REVISED - PLATTING BOARD AGENDA ASSEMBLY CHAMBERS

PLATTING BOARD MEETING

March 20, 2025

A. **SOUTH SHORE WATERFRONT MSP**: The request is to create bring the approved **SOUTH SHORE WATERFRONT MASTER PLAN** back before the board for modification. Petitioner is proposing the northern access road be a private road. This will require the dedication of a new cul-de-sac at the beginning of the private road. Containing 34 acres +/- . The property is located South of Big Lake, West of S. Corkey Boulevard and directly North of W. Susitna Parkway; (Tax ID#17N04W35C009) within the SW ¼ Section 35, Township 17 North, Range 04 West, Seward Meridian, Alaska. In the Big Lake Community Council and in Assembly District #5. . (Petitioner/Owner: Seth Kroenke, Staff: Wyatt Anderson, Case # 2025-001)

BIG LAKE, ALASKA
SOUTH SHORE WATERFRONT
PHYSICAL SECTION/
PROJECT OVERVIEW

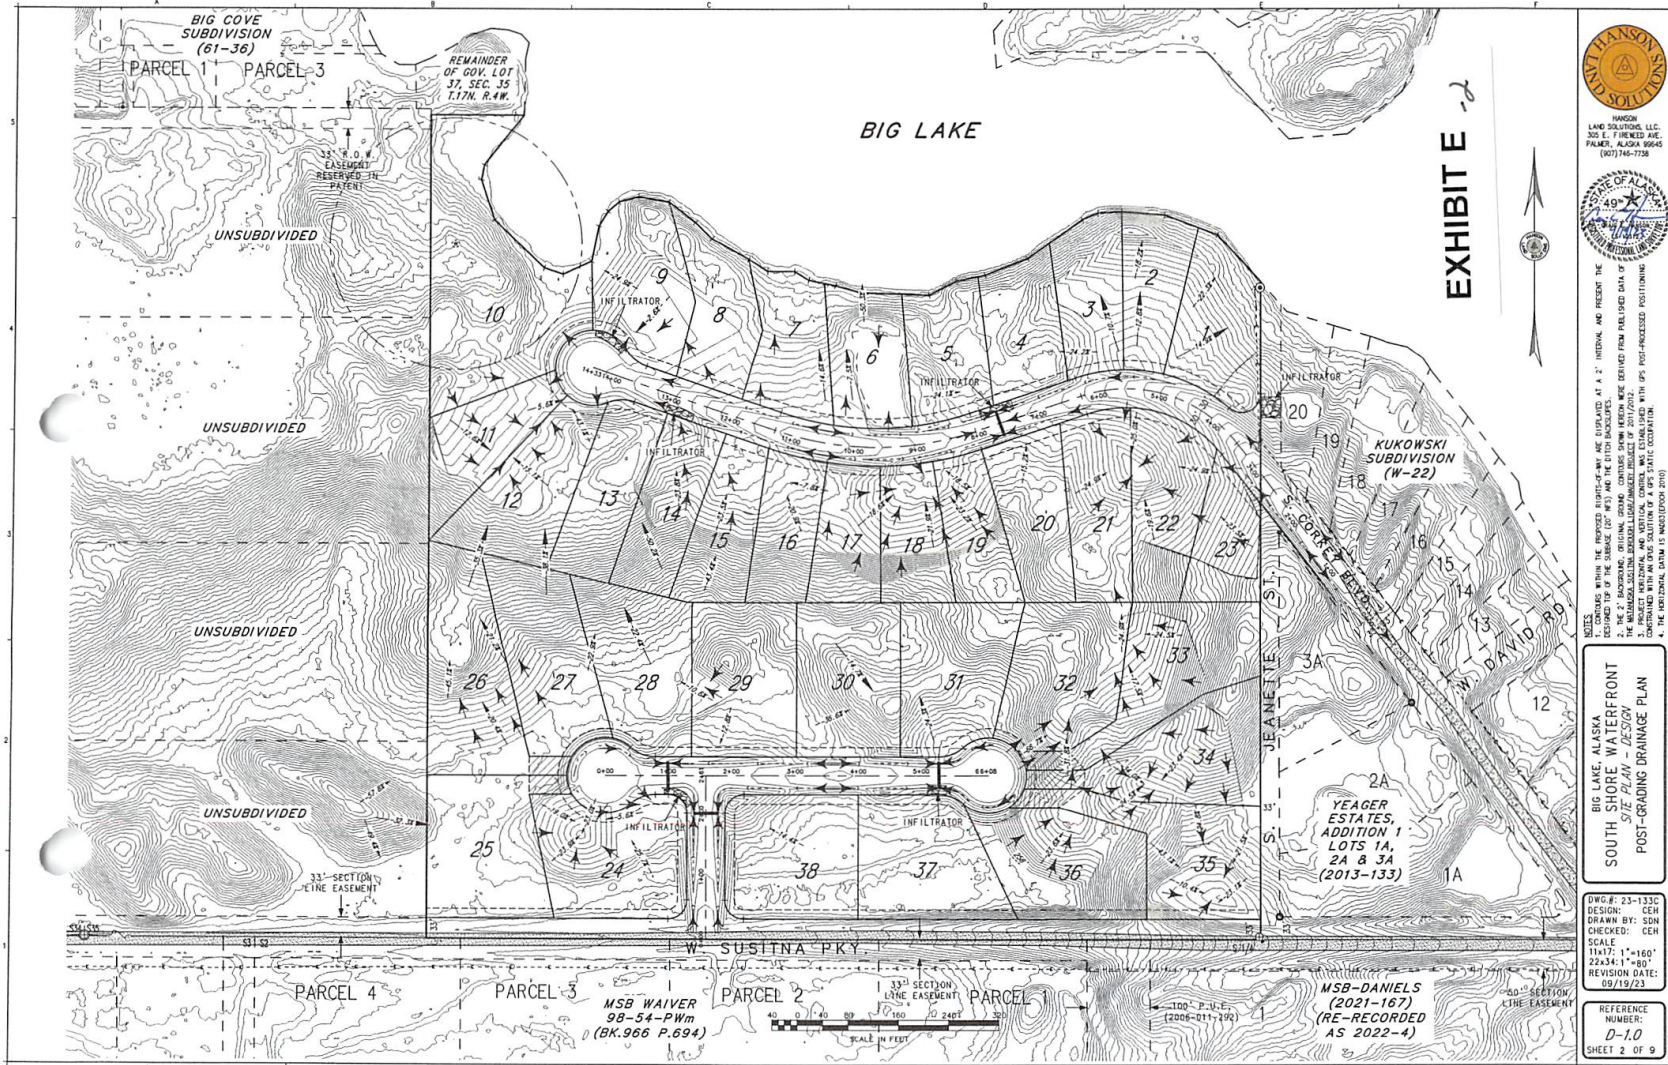
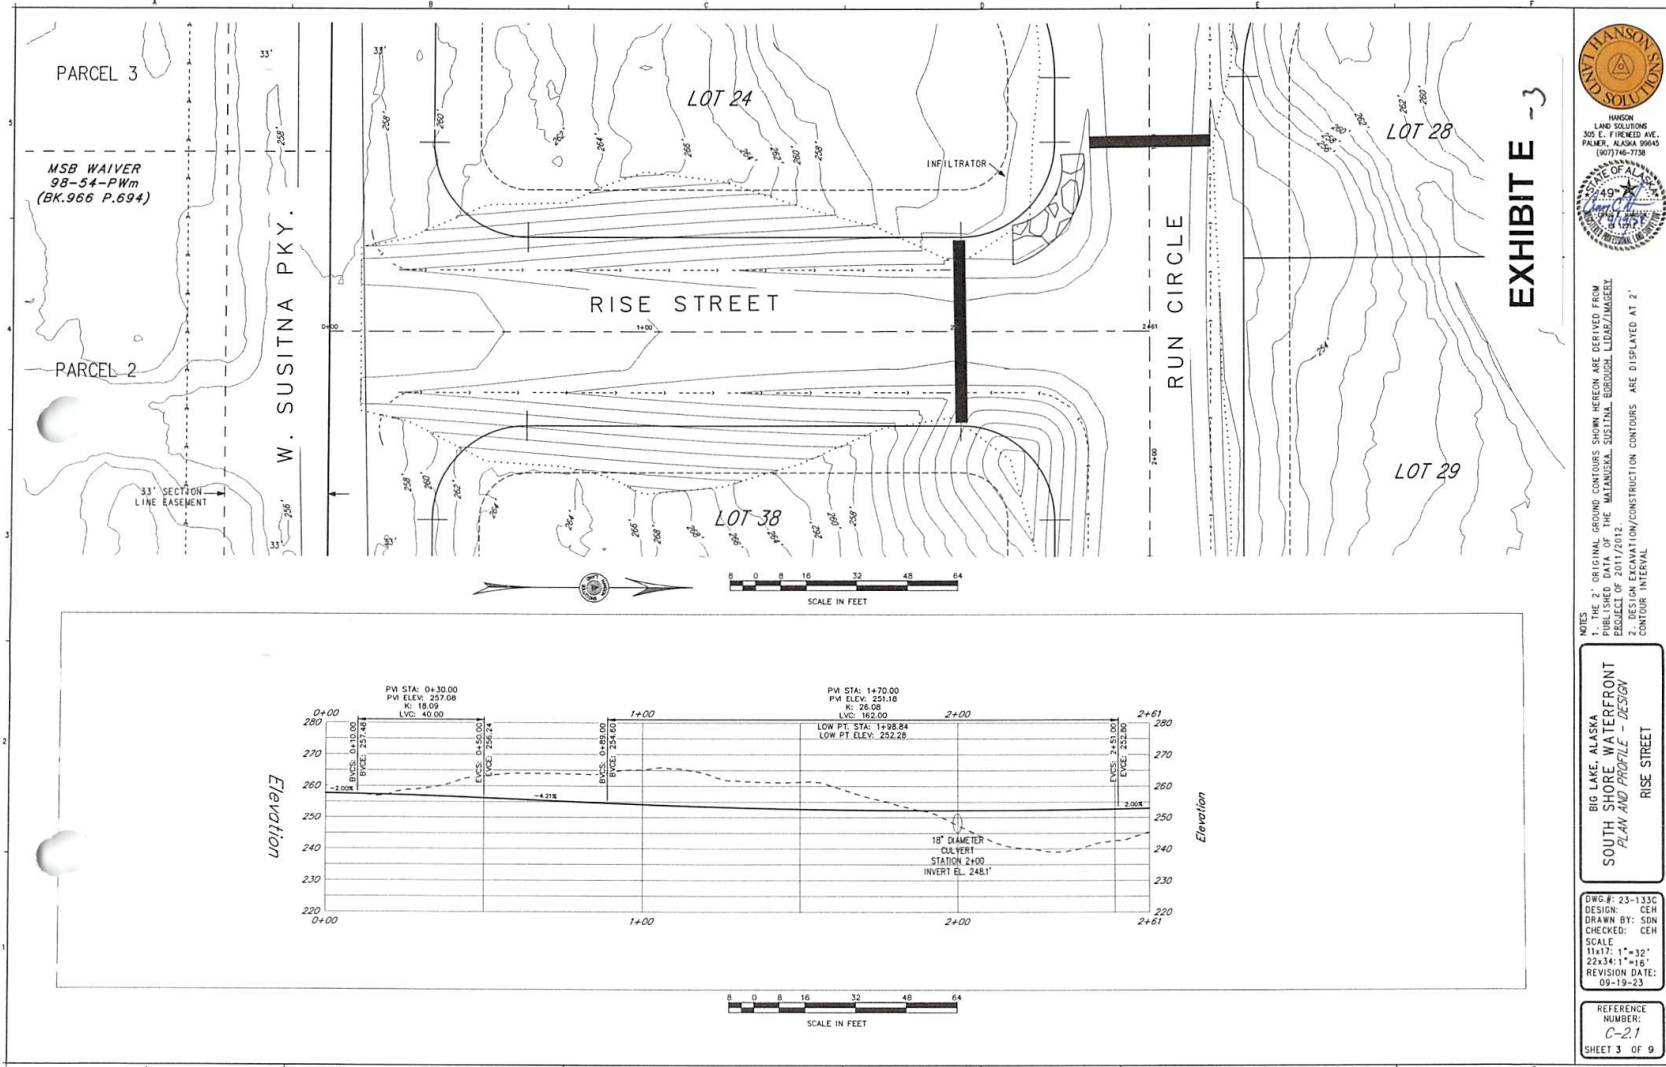
Update and resubmit plan and profile sheets. Sheet C2.7 is missing. Please provide. Update C2.1 to show current design. Update D1.0 and C1.0 to show west cul-de-sac of run circle.

Haven Park Road Design - W Rodney Circle
Draft Road Design - Residential Street Std/25 MPH

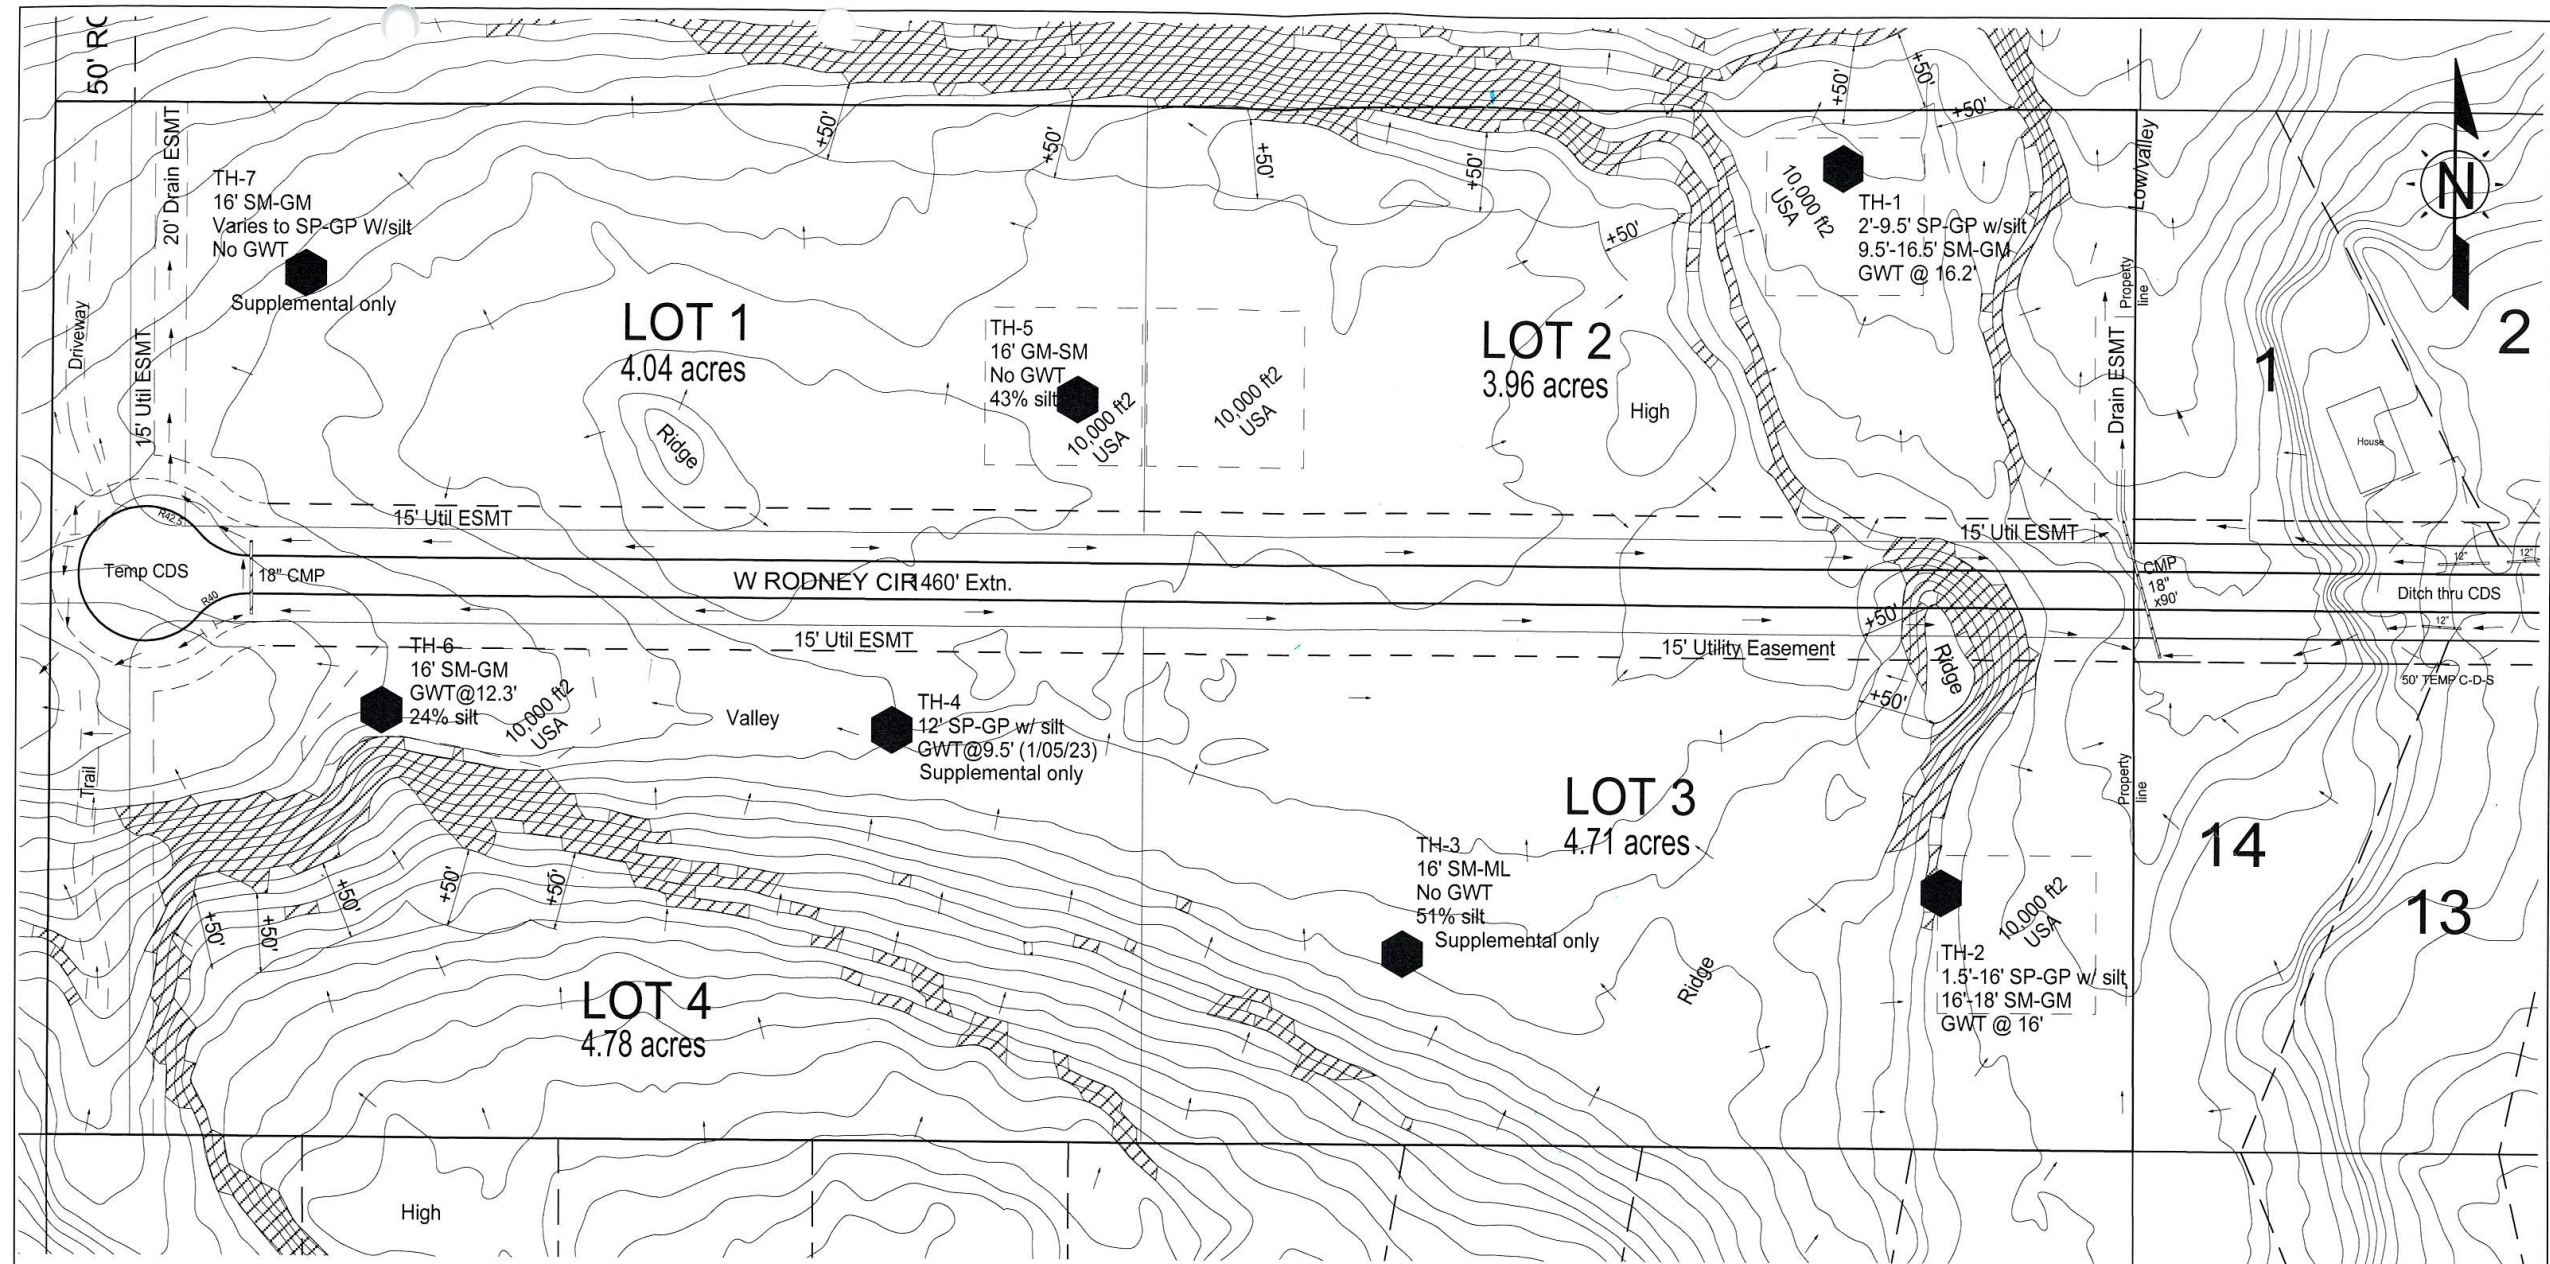
I talked to Curt, and we discussed our concerns about the road embankment fitting in the existing ROW. He mentioned he is planning for careful staking of the ROW, grade staking, and thorough oversight of road construction in this area.

I would like to suggest a condition of approval to the effect of: Ensure construction of the extension of Rodney Circle does not encroach onto private property. If field conditions vary from those depicted in the plan & profile, submit an updated plan & profile showing how this will be achieved.

- g. Ensure construction of the extension of Rodney Circle does not encroach onto private property. If field conditions vary from those depicted in the plan & profile; submit an updated plan & profile showing how this will be achieved.
